Office Action Summary

10/065,357

Applicant(s) claimed invention is directed to an upflow reactor for producing dihydroxy compounds comprising a vessel, a catalyst bed, a reactant distribution, a distributor and a first screen disposed and a collector; a method for producing a dihydroxy compound in an upflow reactor; a method for reducing the amount of catalyst bead carryover from a bed of catalyst beads in an upflow reactor; and a method of manufacturing of a polycarbonate.

FIG. 1 is a schematic cross-sectional illustration that shows a condensate polishing ion exchange vessel utilizing the present invention.

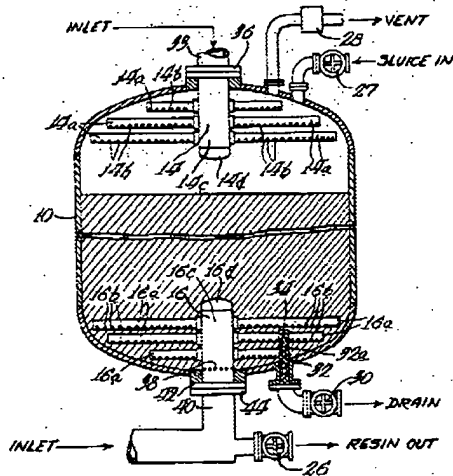
Claims 13, 17, 21 and 25 are rejected under 35 U.S.C. 102(b) as being anticipated by USP 3847805 see abstract, figure 1, cols. 4 –6 and claims 1, 2 and 3.

USP 3847805 discloses an ion exchange vessel containing ion exchange resin comprising a distribution means, liquid supply means connected to said distribution means for providing upward service flow, a collection means positioned above said distribution means, liquid supply means connected to said collection means for selectively providing downward liquid flow, said distribution means comprising unscreened apertured distribution means for both supplying said upward service flow and for removing resin from said vessel when said downward liquid flow is being selectively provided through said vessel and draining means comprising a screened lower drain for selectively draining liquid from said vessel without the removal of any substantial amount of resin from said vessel, said distribution means comprises a hollow hub which protrudes upwardly through the center of the bottom of said vessel and a plurality of hollow radially extending unscreened apertured laterals which are in

fluid communication with said hub, said hub having a plurality of unscreened holes therein which extend circumferentially around said hub adjacent the area where said hub protrudes through the bottom of said vessel.

Thus the reference and upflow reactor and distributor discloses a prepared from the same components as claimed by applicants. Thus in view of the above, there appears to be no significant difference between the reference and that which is claimed by applicant(s). Any differences not specifically mentioned appear to be conventional. Consequently, the claimed invention cannot be deemed as novel and accordingly is unpatentable.
